RE: VACATING WILLOW CREST AVENUE AND BLUFFSIDE DRIVE VACATION DISTRICT IN CONNECTION WITH THE CONSTRUCTION OF THE METRO RED LINE PROJECT – UNIVERSAL CITY STATION (VAC E 1400495)

SUPPLEMENTAL ENVIRONMENTAL IMPACT STATEMENT/
SUBSEQUENT ENVIRONMENTAL IMPACT REPORT

Los Angeles Rail Rapid Transit Project

FIGURE 3-3

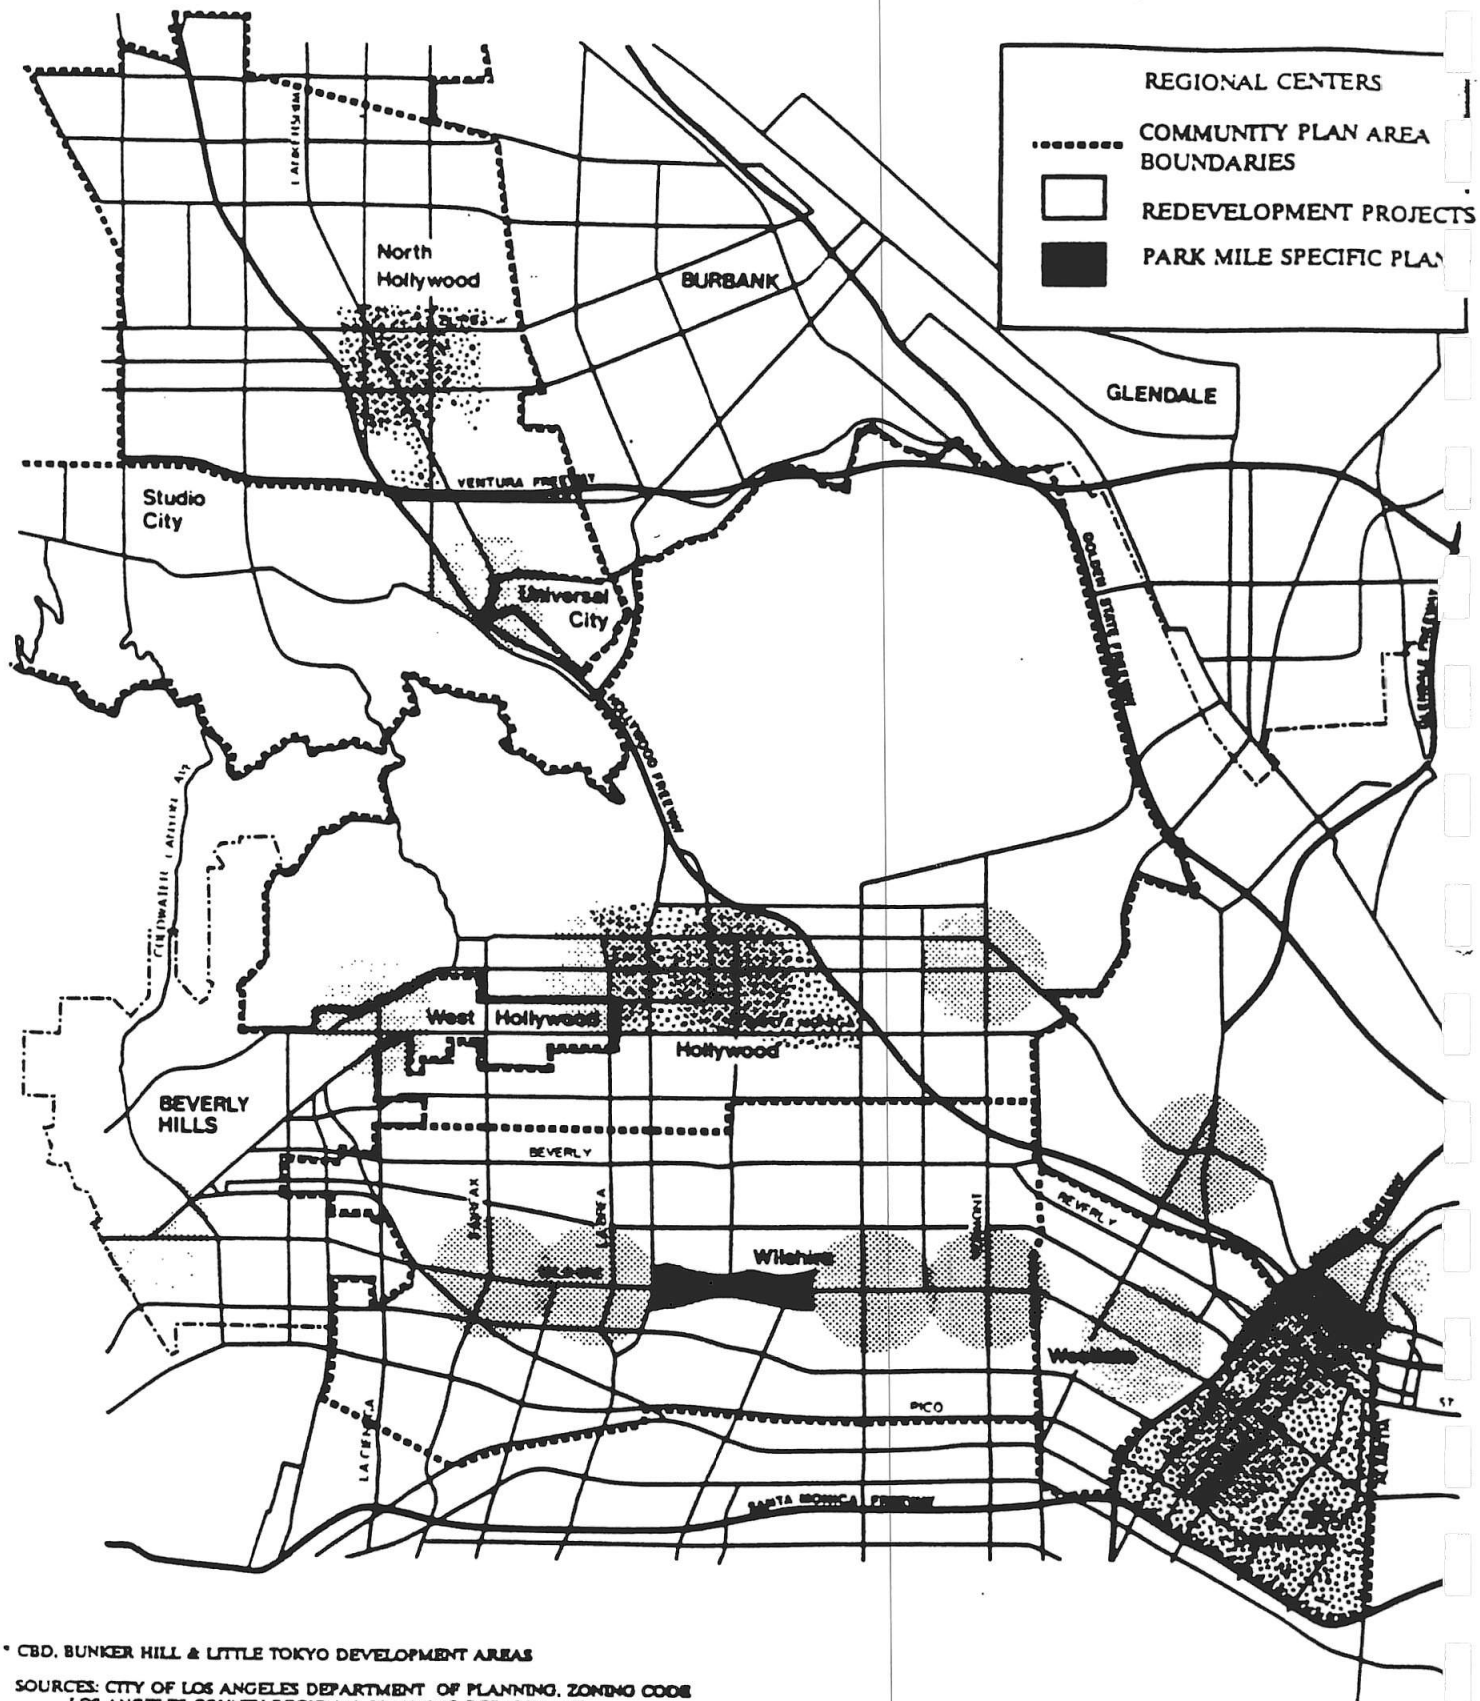
LU2 **COMMENT:** The CRA has three redevelopment areas in the downtown area: the Bunker Hill, Little Tokyo and CBD project areas. Figure 2-7 in the Draft SEIR should include the Little Tokyo CRA area. Other pending and adopted specific plans (Ventura Boulevard, Park La Brea, Koreatown and Westlake) could be added. (City of Los Angeles Planning Department)

ANSWER: Figure 2-7 (now Figure 3-3 of the Final SEIS/SEIR) has been changed to include these areas in addition to the CBD Project area.

FIGURE 3-4

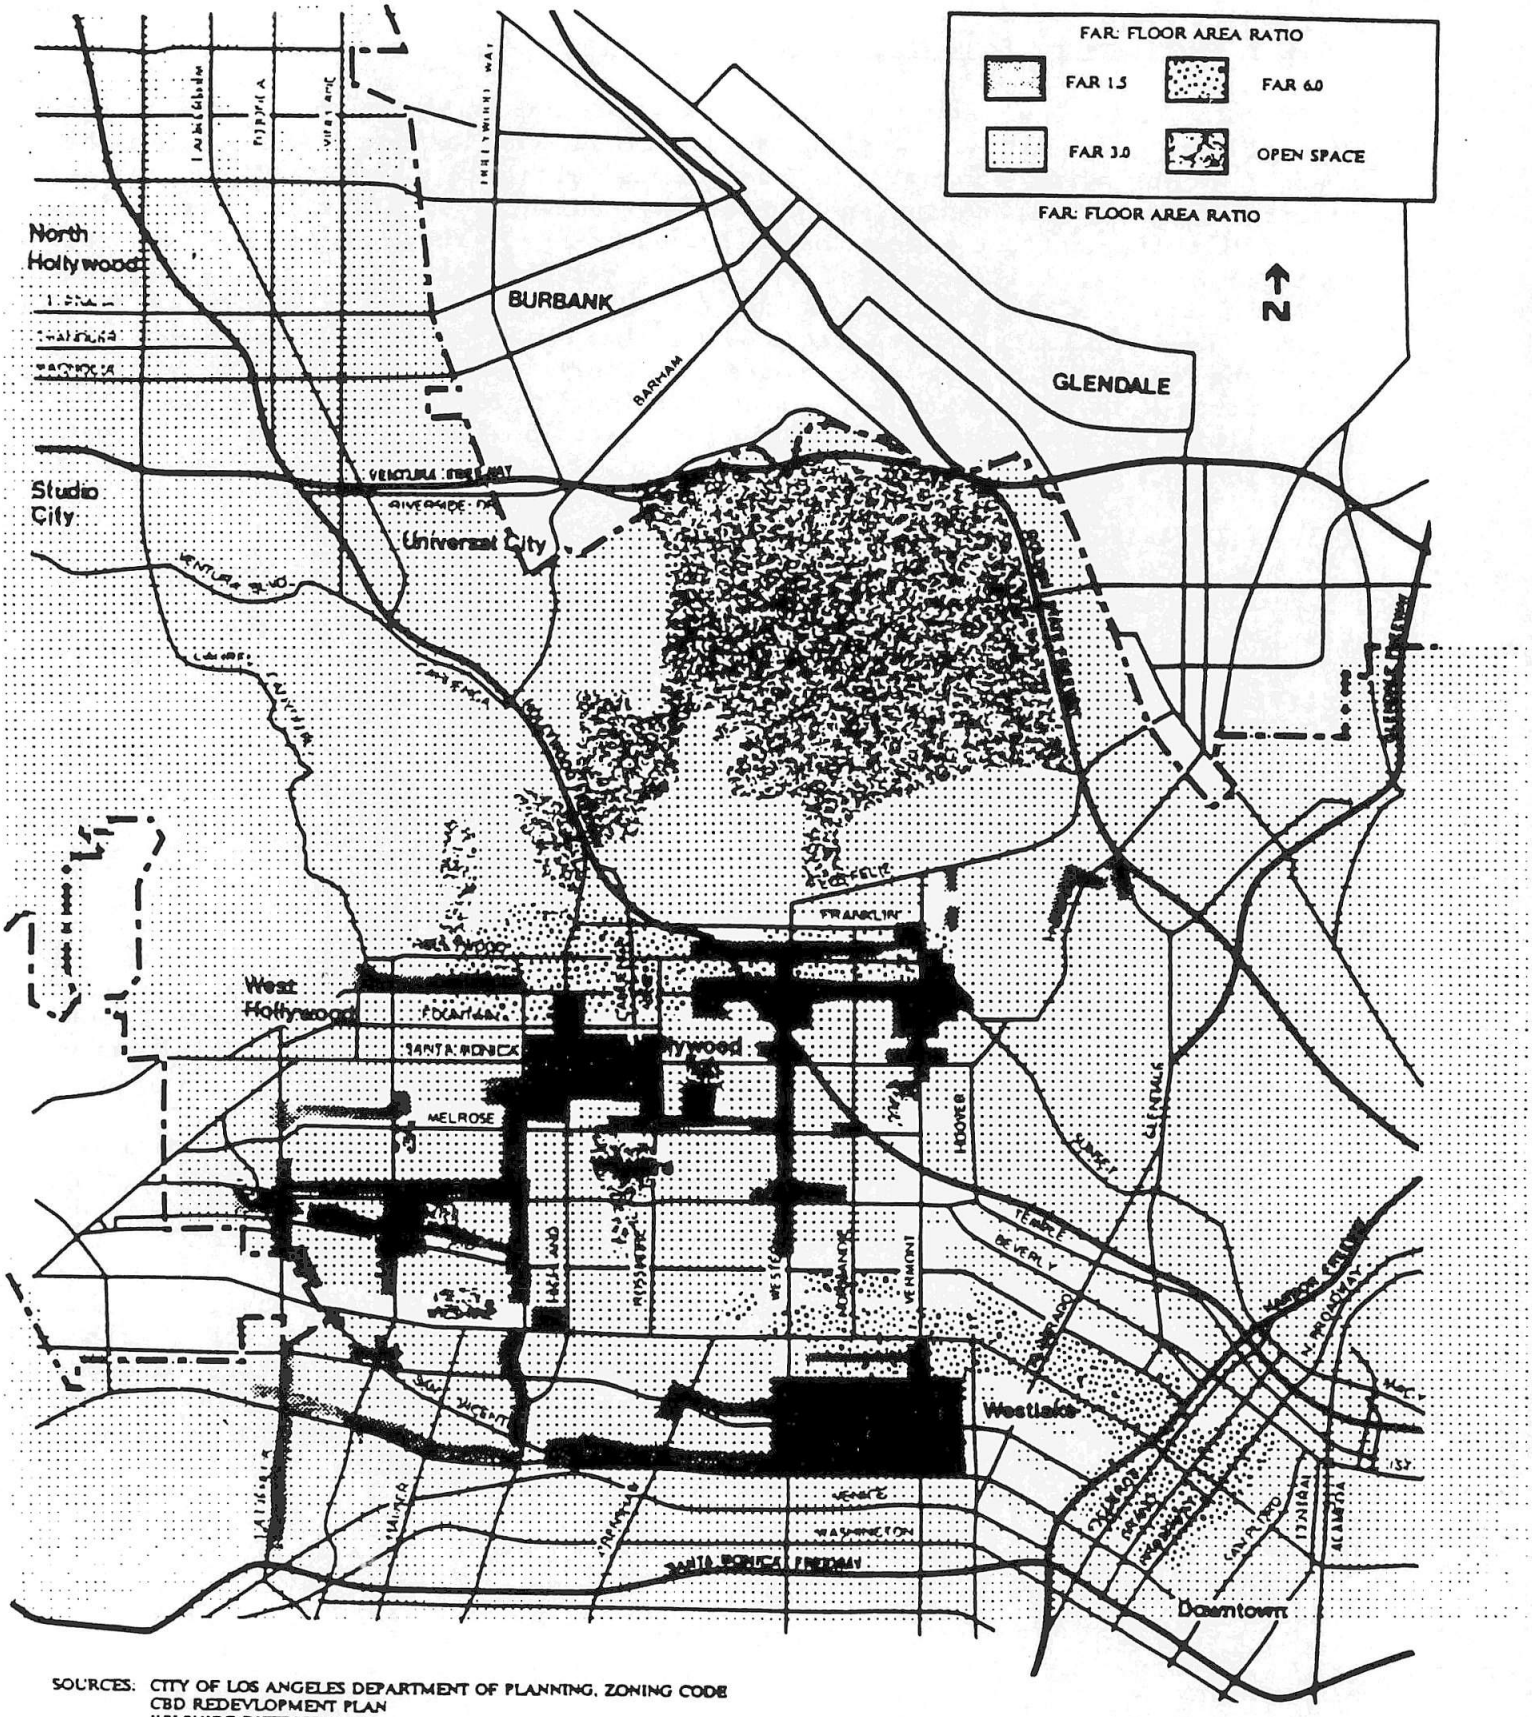
LU24 **COMMENT**: Regarding Figure 2-8 in the Draft SEIR, a review of current Community Plan-permitted densities and uses reveals that nearly all areas indicated for FAR 13:1 on the map permit only a 6:1 development level, while most shown for 10:1 and 6:1 allow levels only up to 3:1. Much of the area of the Santa Monica Mountains in Hollywood and Studio City shown as open space is designated for low density residential use. (City of Los Angeles Planning Department)

ANSWER: Figure 2-8 has been revised using data from the City of Los Angeles Municipal Code (Zoning Code), the CBD Redevelopment Plan, the Wilshire District Plan, the Park Mile Specific Plan, the Westlake Community Plan and the North Hollywood Community Plan. The FAR data used in the land use analysis was taken from Table 3-1 (page D-43 in the Appendix to the Draft SEIS/SEIR) and not from Figure 2-8.
